Vision-RTK 2 Release Notes

Release v2.123.7

MAY, 2026

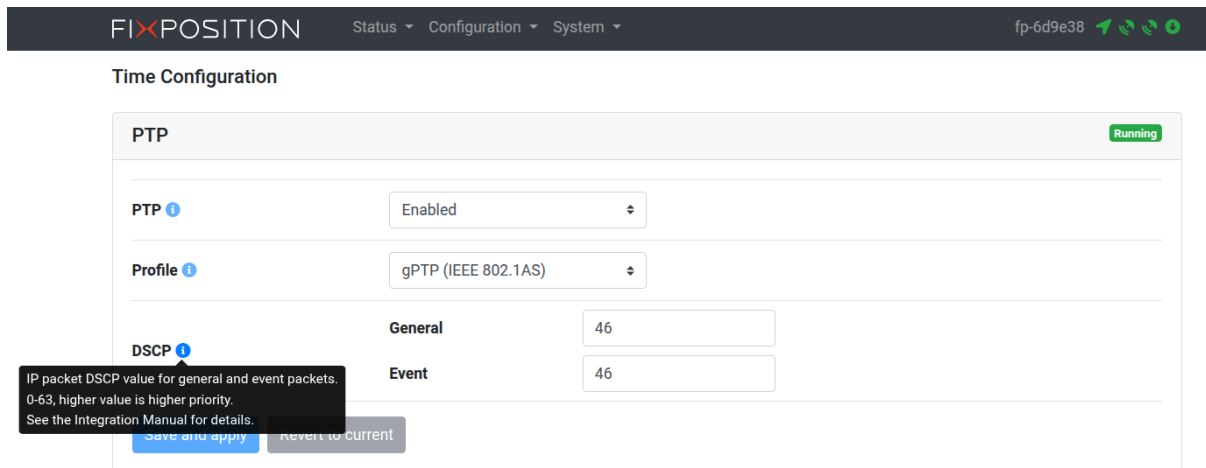
- Added UI for configuring PTP DSCP IP packet parameters, see Section 3

- Add feature for configurable PTP DSCP IP packet parameters, see Section 3. Default values are 46 for General and Event.
- Increased update rate of status updates on the FP_A-ODOMSTATUS message.

3.1 Configurable PTP DSCP IP packet parameters

With this patch, the VRTK-2 now features a configurable PTP DSCP (Differentiated Services Code Point) IP packet parameter function, fully compatible across all supported PTP (Precision Time Protocol) protocols. This allows for precise Quality of Service (QoS) traffic prioritization on your network.

Defaults: Out of the box, and if PTP is enabled, both the Event and General PTP parameters are pre-configured to 46 (Expedited Forwarding / EF).
